Project	IEEE 802.16 Broadband Wireless Access Working Group < http://ieee802.org/16 >
Title	MCS Level Addition for Lower Rate Coding
Date Submitted	2004-08-20
Source(s)	Myung-Kwang Byun, Heesang Seo, mk.byun@samsung.com Jiho Jang, Ikbeom Lee, Seungjoo Maeng, Jaeho Jeon Samsung Electronics Co., Ltd. Dong Suwon P.O.Box 105 416, Maetan-3dong, Yeongtong-gu, Suwon-city, Gyeonggi-do, Korea 442-600
Re:	
Abstract	Propose to add two MCS levels of QPSK 1/12, QPSK 1/24
Purpose	Adopting of proposed method into P802.16e
Notice	This document has been prepared to assist IEEE 802.16. It is offered as a basis for discussion and is not binding on the contributing individual(s) or organization(s). The material in this document is subject to change in form and content after further study. The contributor(s) reserve(s) the right to add, amend or withdraw material contained herein.
Release	The contributor grants a free, irrevocable license to the IEEE to incorporate material contained in this contribution, and any modifications thereof, in the creation of an IEEE Standards publication; to copyright in the IEEE's name any IEEE Standards publication even though it may include portions of this contribution

Figure 1—Link performances with four kinds of MCS levels

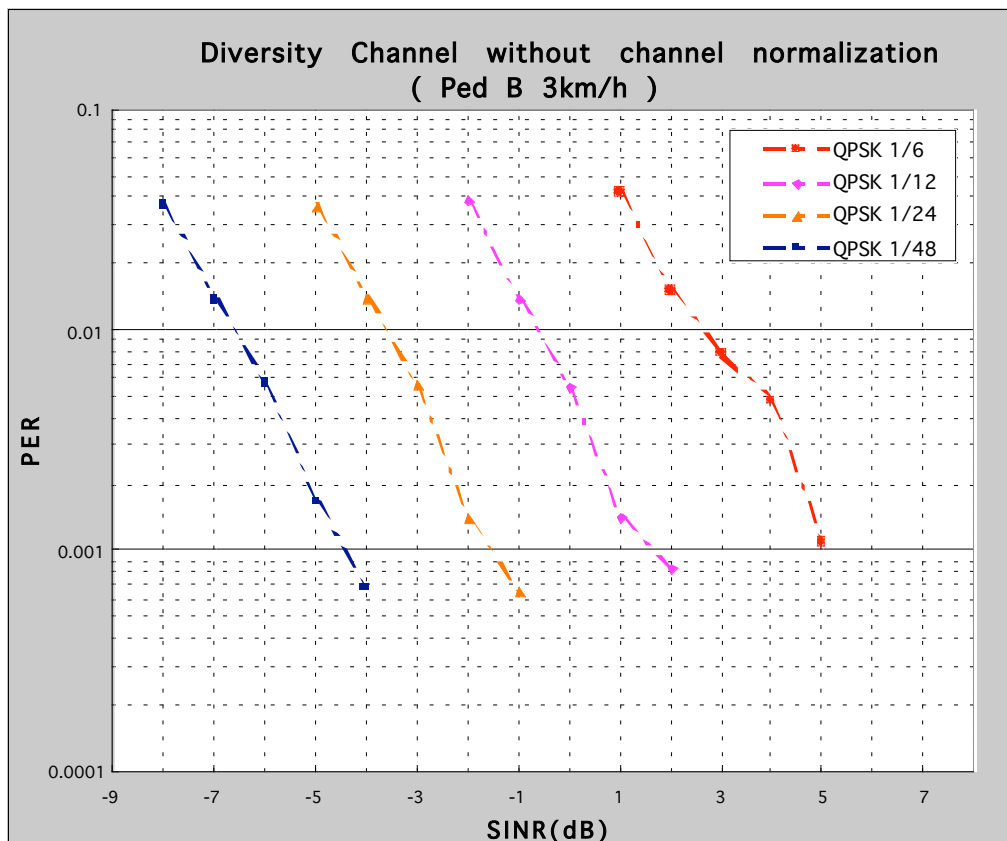
Simulation results of the link performances of the two proposed MCS levels (QPSK 1/24, QPSK 1/48) are shown in Figure 1. The link performances of the two currently lowest rate MCS levels (QPSK 1/6, QPSK 1/12) are also shown in the figure. In the simulations, Ped-B channels with 3 km/h velocity are considered. Figure 1 shows PER (Packet Error Rate) versus SINR (Signal to Interference and Noise Ratio per subcarrier) with various MCS levels. We can see that in the error rate of 10^{-2} region, the QPSK 1/12 requires SINR of -0.7 dB which cannot be satisfied with high probability for the case of cell boundary users, however QPSK 1/48 requires SINR of only -6.7 dB. Since the ideal channel estimation is assumed in the simulation, the performance may be degraded by few dB in real situation.
